Subject:

Timing Belt System replacement on VAG 1.8 20V engines (PowerGrip® Belt and Kits 5492XS)

Fig. 1 new system

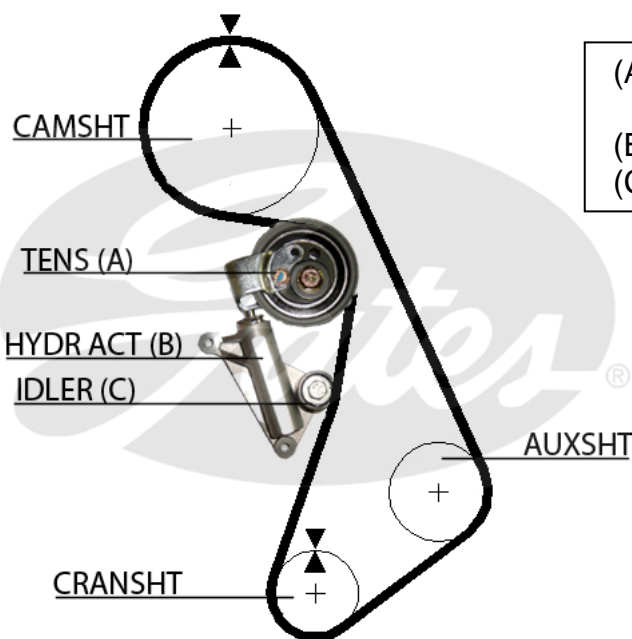
After durability problems it was decided to reengineer the synchronous system and to use an OE belt 058109119B/058109119C (5492XS - 153 teeth) together with a hydraulic actuator⁽²⁾ 058109479B and a new tensioner pulley 058109243E (new system – Fig. 1).

Note: The old system is no longer available on OES level. It is strongly recommended to replace the entire system with the new system (Fig. 1) when the original timing belt needs replacement. Please make sure that parts of the old and new system are not being interchanged in order to avoid engine damage.
